Stallan-Brand

Date: 25/03/2024

2027.00 Moss Lane East, Manchester

Design and Access Statement Addendum

Roof Plan as Amended

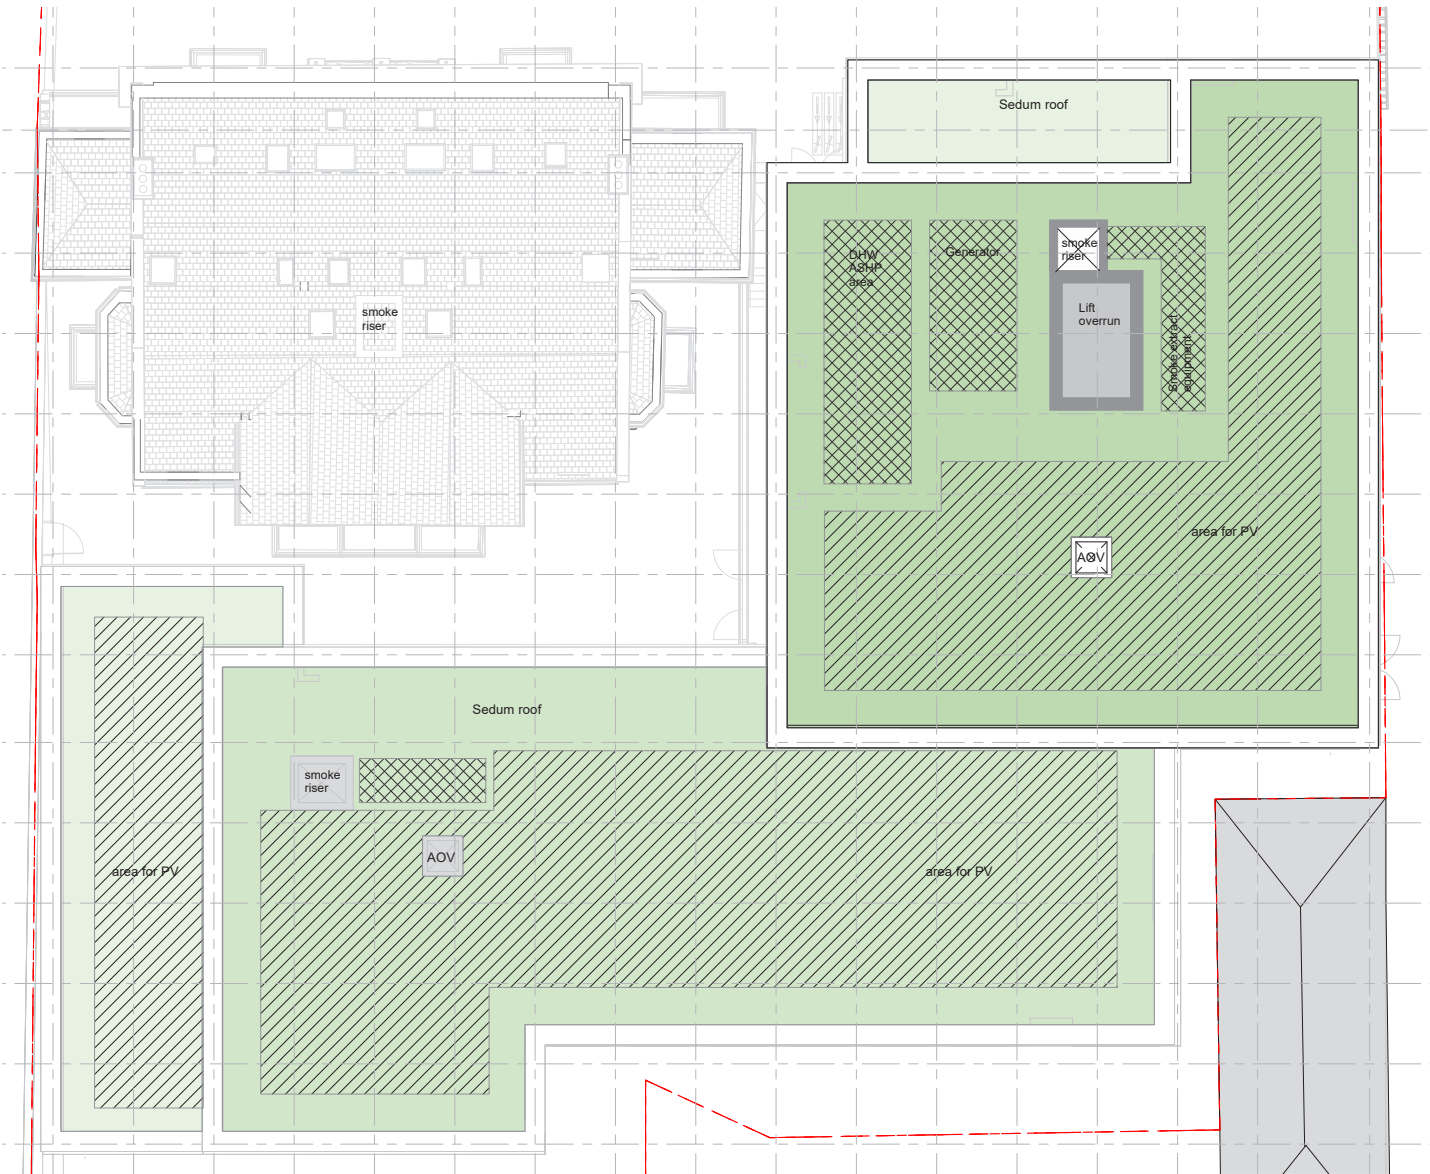
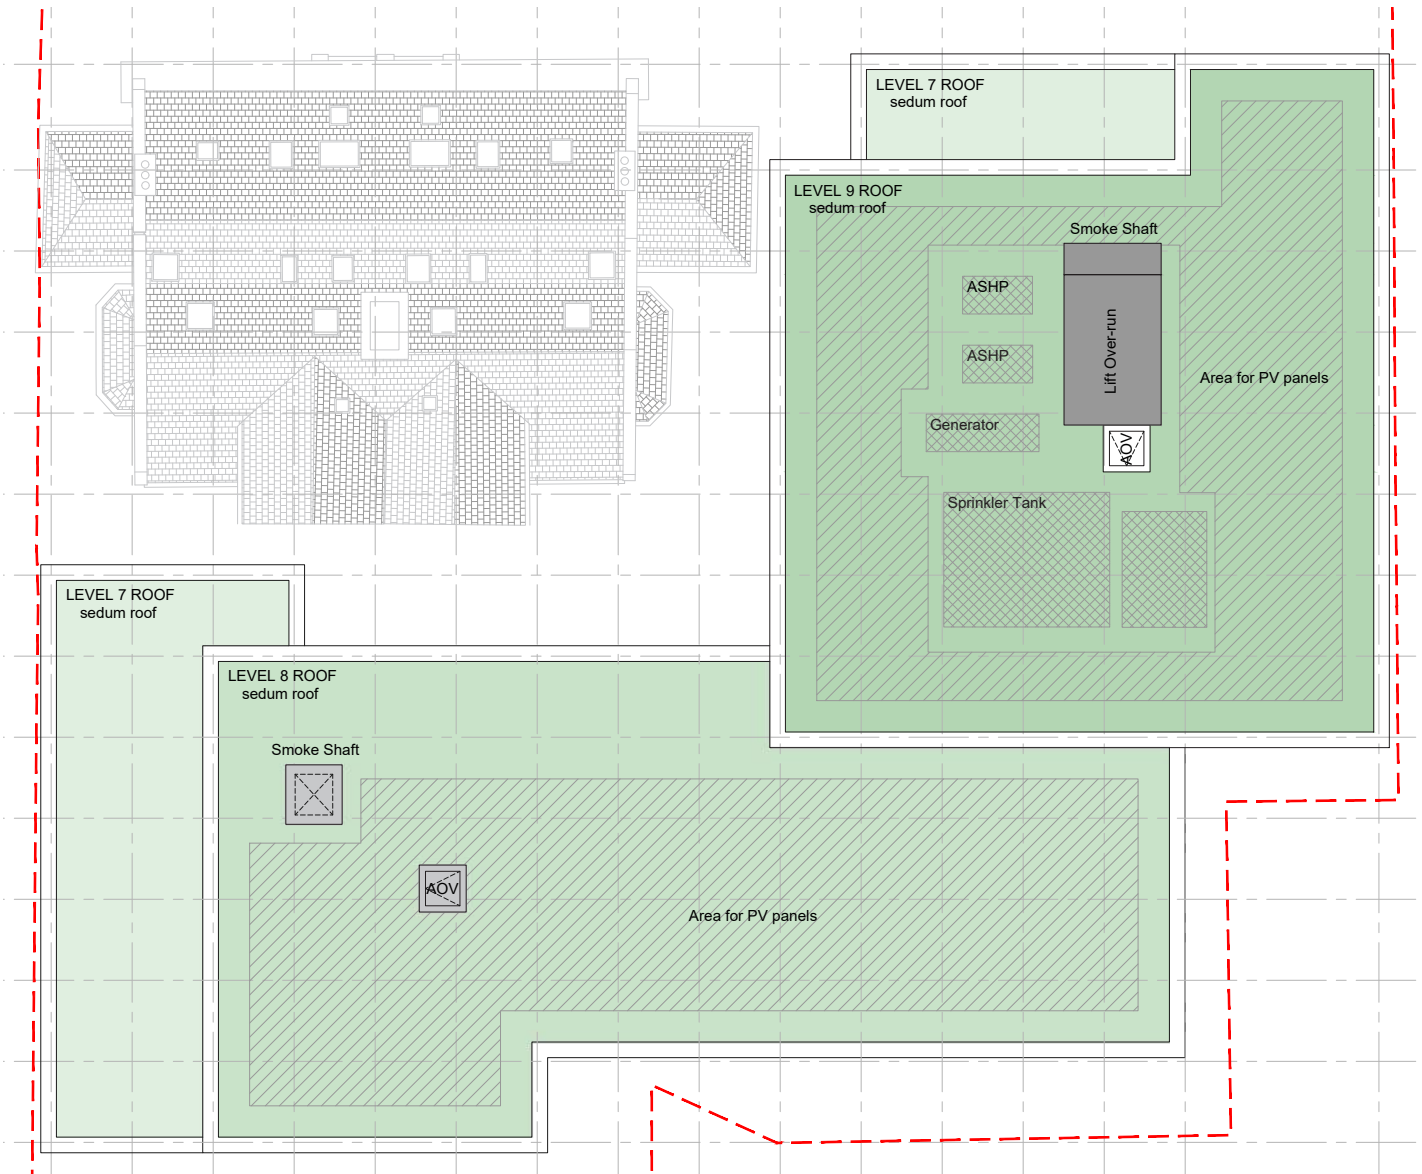
The MEP plant equipment located at rooftops has been developed to help minimise its visual impact and to accommodate the relocation of plant room, the following has been proposed -

- Reconfiguration of rooftop MEP plant to increase its distance from roof edge
- Part of plant equipment relocated from the omitted basement to rooftop

- Rooftop plant layout re-arranged and large items relocated to the centre of the roof plan

Typical Level Part Plan as Amended

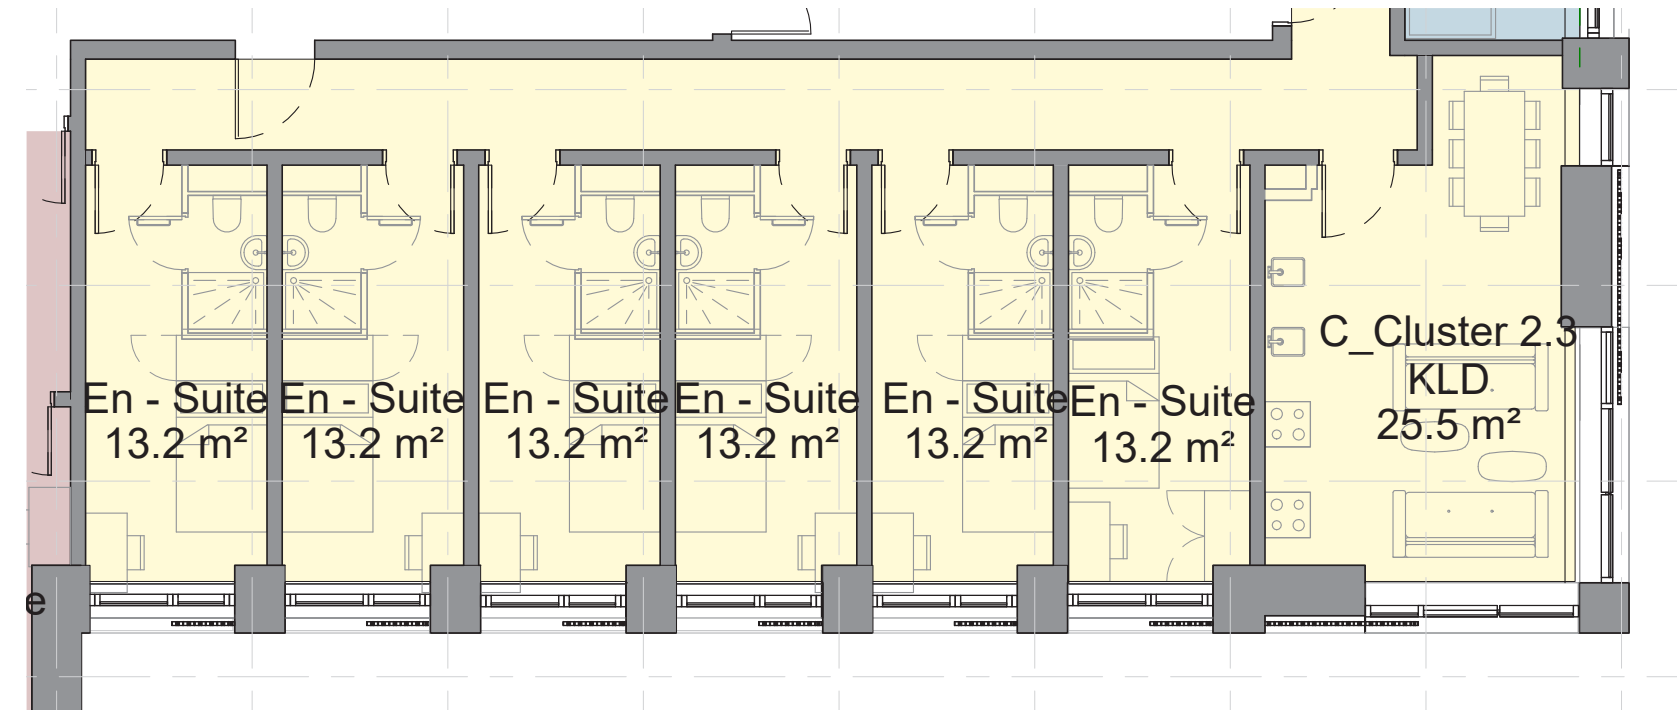
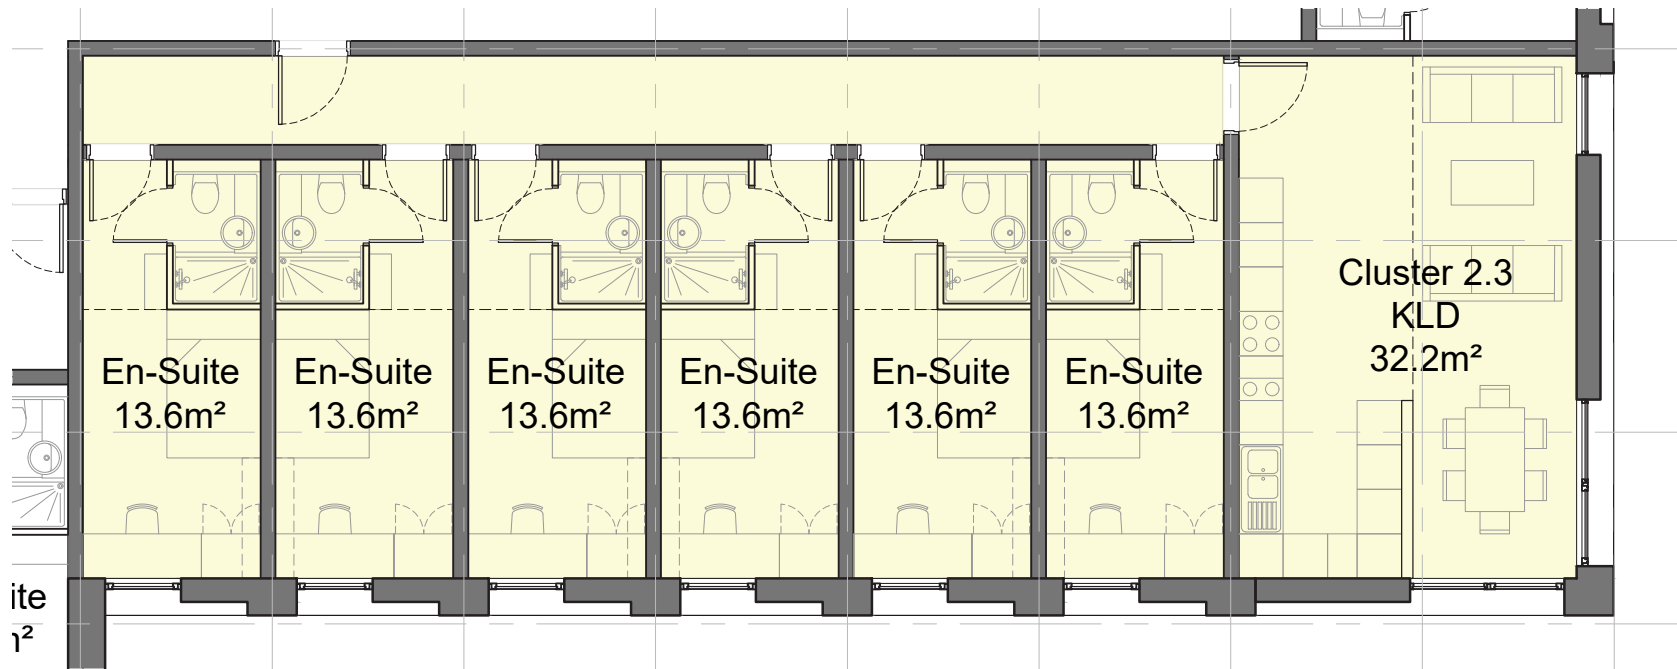
In tandem with the proposed optimizing of the internal layouts and functionality of the individual rooms, a consideration has also been given to finding ways to maximize the internal wall surfaces within the bedrooms and thus provide more space for furniture, to bring this in line with the client brief.

In keeping with the originally intended facade aesthetics and the proposed room proportions, an alternative approach to the window detail has been developed in order to allow for substantially improved furniture provision within the bedrooms and the result accommodation standard, naturally integrated into the proposed design.

- Increase of solid portion of external wall (to all accommodation areas)

- Glass panel and mesh screen replaced with insulated solid infill panel with decorative finish

Basement Plan as Amended

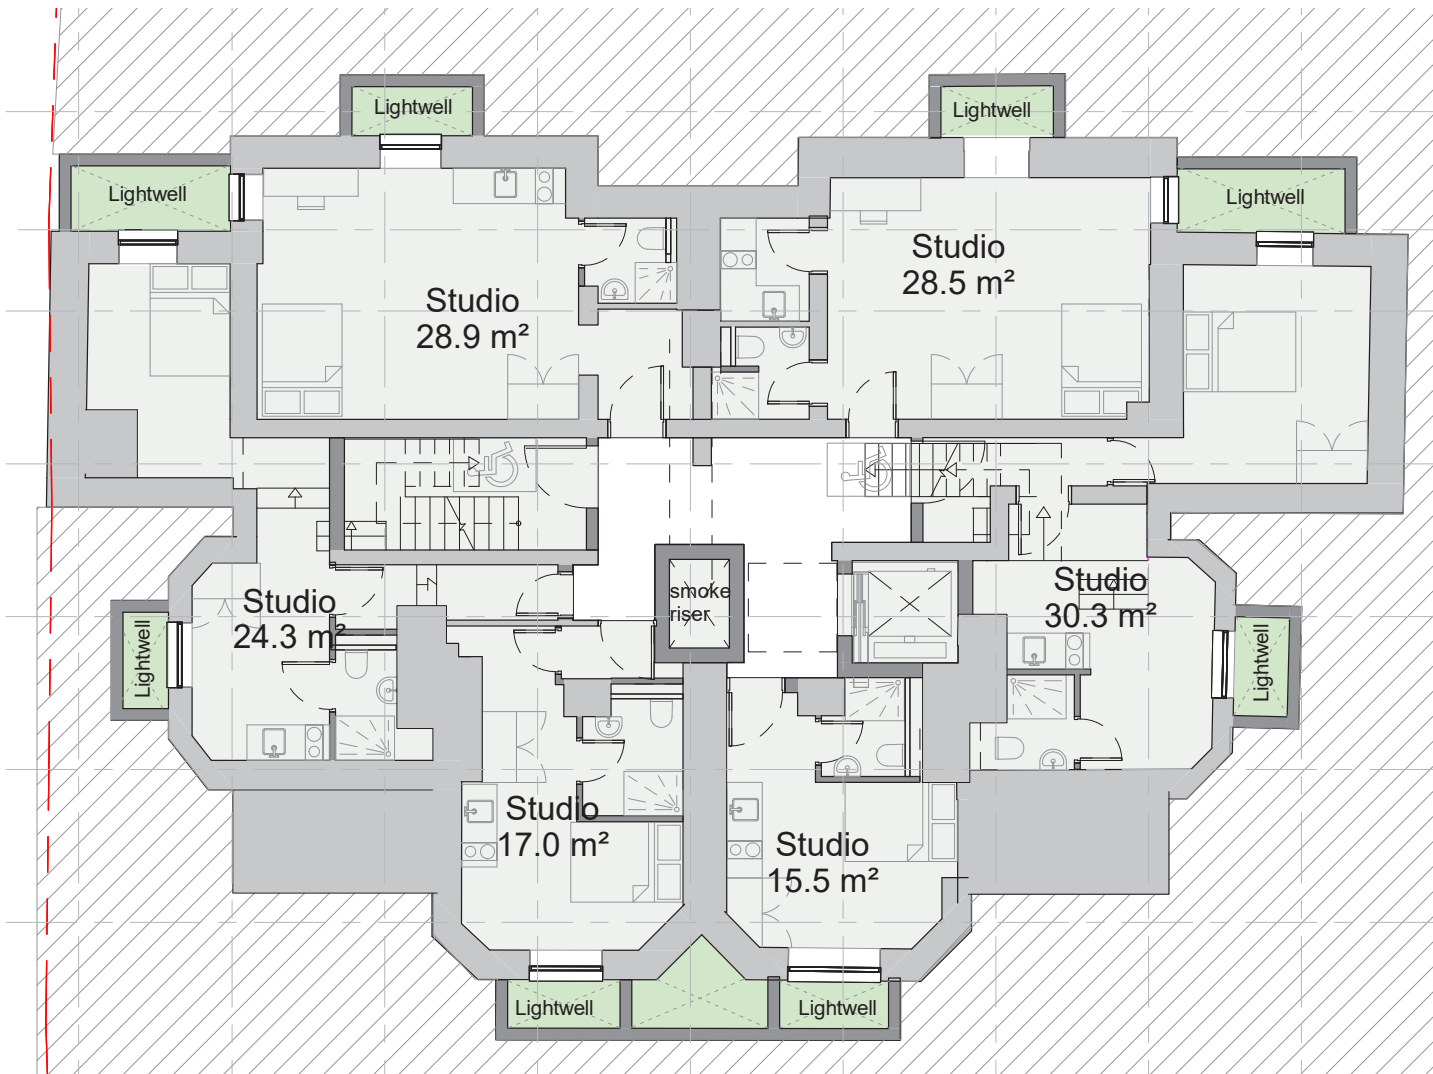
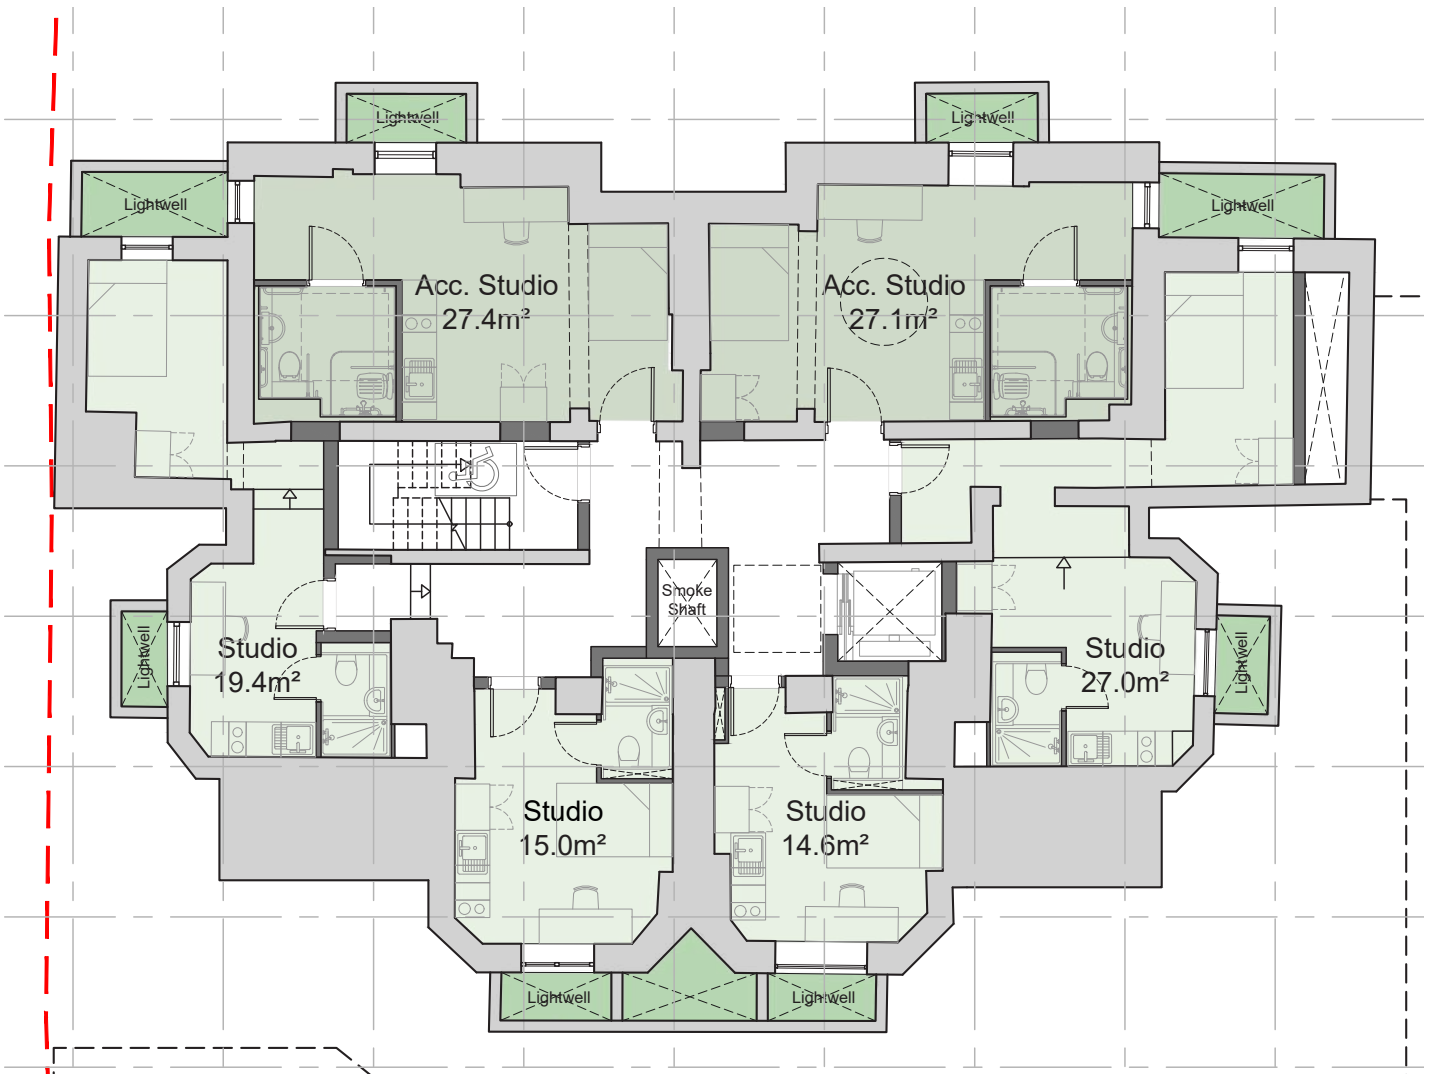
To ensure Building Regulations compliance for accessible accommodation, to clarify layouts and overall arrangement within the building, the following has been proposed -

- Adjustments to 7no. Studios

- Adjustments to Studio furniture layouts (all)

- Studios at Basement, First and Second floor altered to accessible, including their furniture arrangement and sanitary facilities
- Studio furniture layouts reconfigured to increase distances between kitchens and beds / escape doors
